SUBJECT: SEP TOPIC IX-4, BORON ADDITION SYSTEM
SAN ONOFRE

Enclosed is a copy of our final evaluation of SEP Topic IX-4. This evaluation incorporates comments provided to us by your letter dated June 25, 1981. We now consider this evaluation to be final.

SYSTEMATIC EVALUATION PROGRAM BRANCH
TOPIC IX-4, BORON ADDITION SYSTEM
SAN ONOFRE PLANT

FIGURE 1

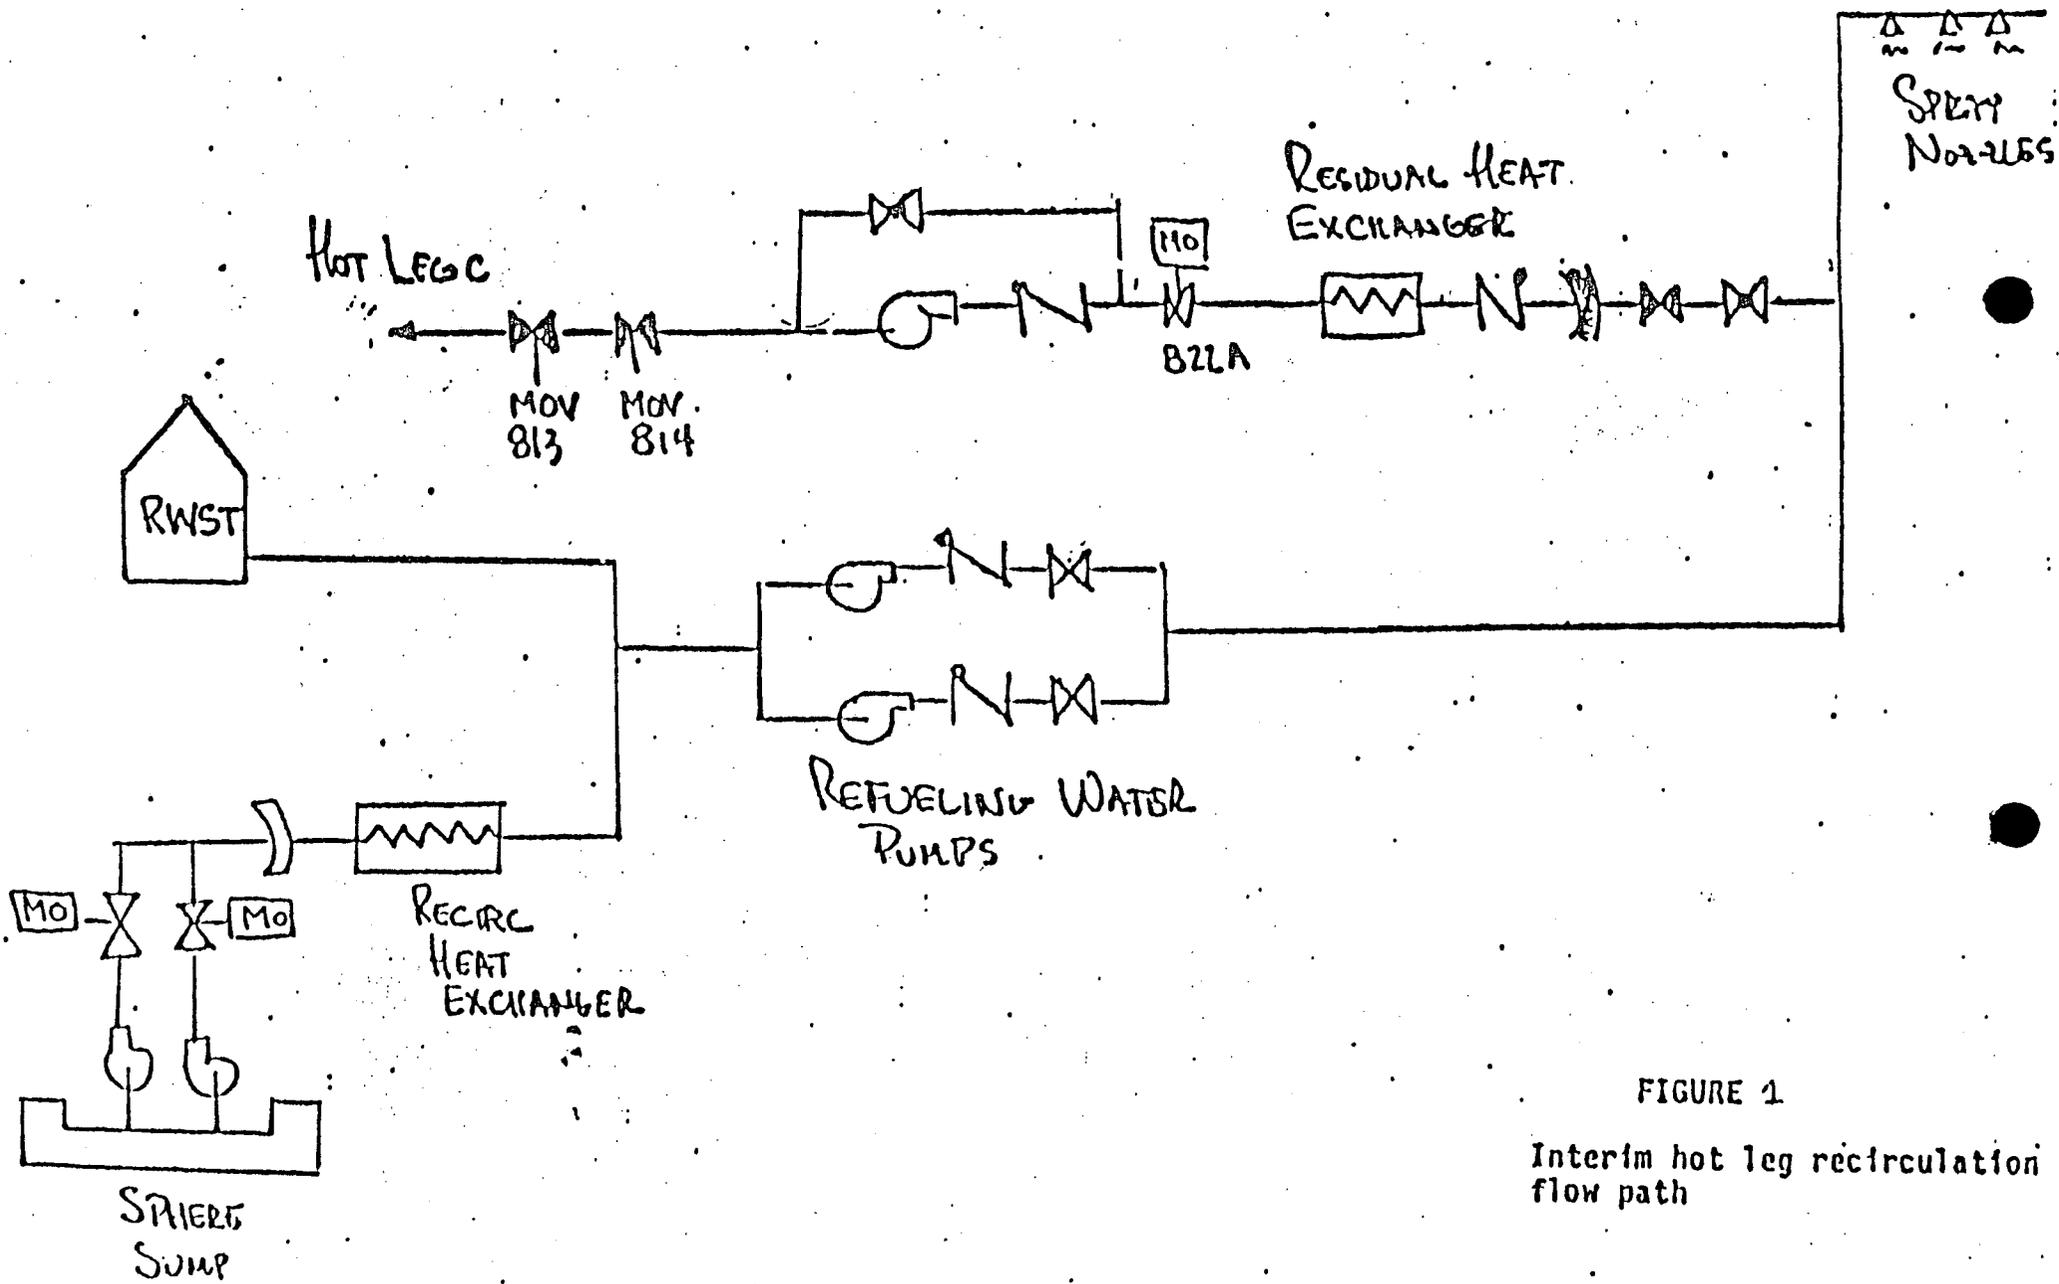
At the present time, several single failures could prevent, or at least reduce, flow through the Hot Leg Recirculation System. An acceptable modification to prevent these single failures involved the installation of redundant valves in the path to the loop B hot leg. SCE, in their letter dated August 10, 1978, as supplemented by letter dated September 15, 1978, submitted a proposal to postpone the implementation of four ECCS single failure modifications to permit evaluation of the potential impact of other plant modifications which may be considered as part of the integrated assessment of the facility in the Systematic Evaluation Program (SEP). Postponement of the above modification was granted by the NRC in a letter dated October 16, 1978. Until these modifications can be made, a means to provide adequate hot leg recirculation in the unlikely event of a loss-of-coolant accident in one of the cold legs and the single failure of one of the valves in the hot leg recirculation path has been developed.

This alternate hot leg recirculation flow (see Reference 1) will provide borated recirculation water to loop "C" hot leg of the reactor coolant system via the residual heat removal letdown line bypassing the RHR pump, rather than through the pressurizer spray to hot leg "B" (see Figure 1). Thus, a single failure will not prevent Dual Recirculation.

Based on our review and using staff criteria referenced earlier, we conclude that the staff analysis of the dual recirculation documented in Amendment No.25 is judged to be acceptable. However, as stated in the SE the licensee has postponed the implementation of ECCS single failure modifications to this system pending their evaluation of the impact of other plant modifications as part of the Systematic Evaluation Program on the ECCS single failure modifications. This delay will have no effect on plant safety since an alternative flow path has been developed in the interim. A schedule for the implementation of these ECCS single failure modifications will be considered during the integrated assessment.
